**Fuel Pipe – Rattle –
Install Pipe Clip****MODEL** 1995 MY
Sedan (4.0l) Range
VIN
720001 - 738089**ISSUE:**

ILLUSTRATION 1

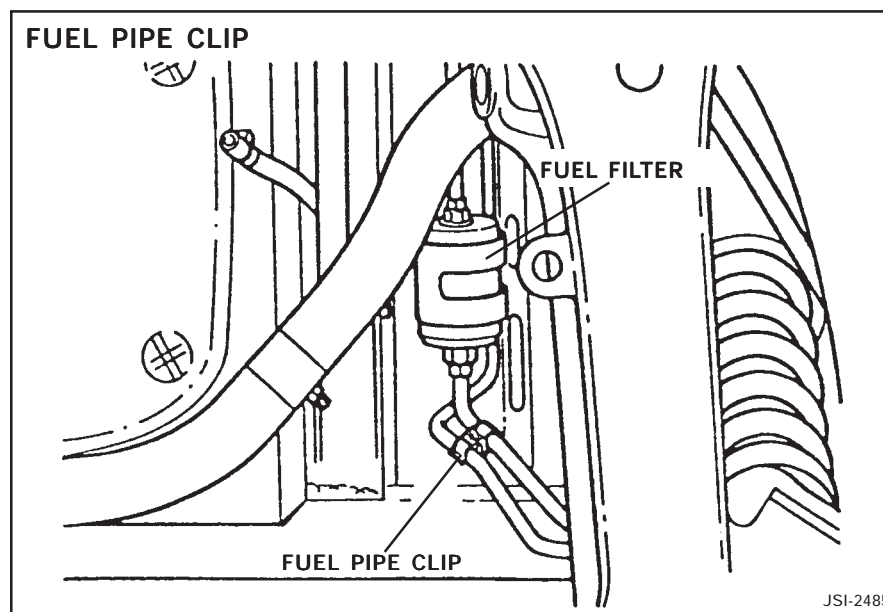
1995 MY Sedan Range vehicles within the VIN range above may experience a light rattle from the rear. The rattle occurs at idle with the vehicle stopped. A plastic fuel pipe clip was installed in production at VIN 738090 to stabilize the fuel pipes and prevent the possibility of a rattle.

1. Check the alignment of the fuel feed and return pipes near the fuel filter. The fuel pipes must not come into contact with any body member or adjacent pipes.
2. Install a plastic pipe clip (part number KDG 108104) between the fuel pipes as shown in Illustration 1.
